<b>Well Name:</b> CARSON UNIT 15	<b>Well Location:</b> T25N / R12W / SEC 15 / SENE / 36.40167 / 108.09221	<b>County or Parish/State:</b> SAN JUAN / NM
<b>Well Number:</b> 342	<b>Type of Well:</b> CONVENTIONAL GAS WELL	<b>Allottee or Tribe Name:</b>
<b>Lease Number:</b> NMNM070322	<b>Unit or CA Name:</b> CARSON UNIT--FRCL	<b>Unit or CA Number:</b> NMNM78385D
<b>US Well Number:</b> 3004527670	<b>Well Status:</b> Producing Gas Well	<b>Operator:</b> DJR OPERATING LLC

**Notice of Intent**

**Type of Action:** Plug and Abandonment

**Plug and Abandonment Procedure**  
**for**  
**DJR Operating, LLC**  
**Carson Unit 15 342**  
**API # 30-045-27670**  
**SE/NE, Unit H, Sec. 15, T25N, R12W**  
**San Juan County, NM**

**DJR Operating, LLC**  
**Proposed Wellbore Diagram**

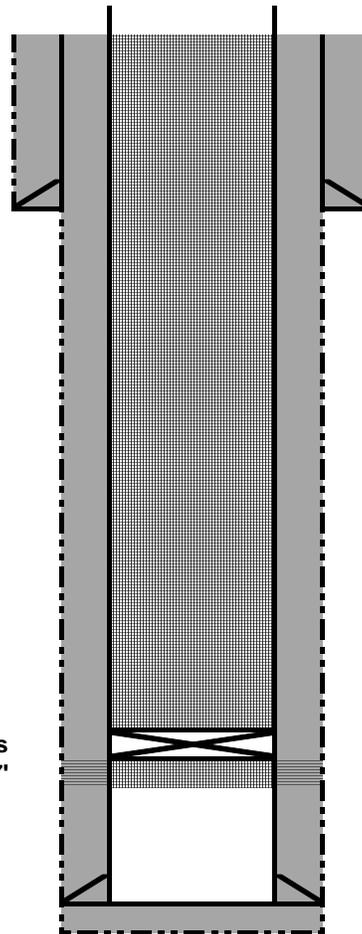
- BLM formation top picks for the Kirtland and Ojo Alamo formations vary from operator picks. No change to the P&A procedure is required (entire well bore will be cemented to surface).
- Log analysis of reference well #2 indicates the Nacimiento and Ojo Alamo sands investigated likely contain fresh water ( $\leq 5,000$  ppm TDS). P&A procedure has cement from the cement retainer @ 980' to Surface which will protect freshwater sands in this well bore.
- Fruitland Coal perforations @ 1022-1037'.
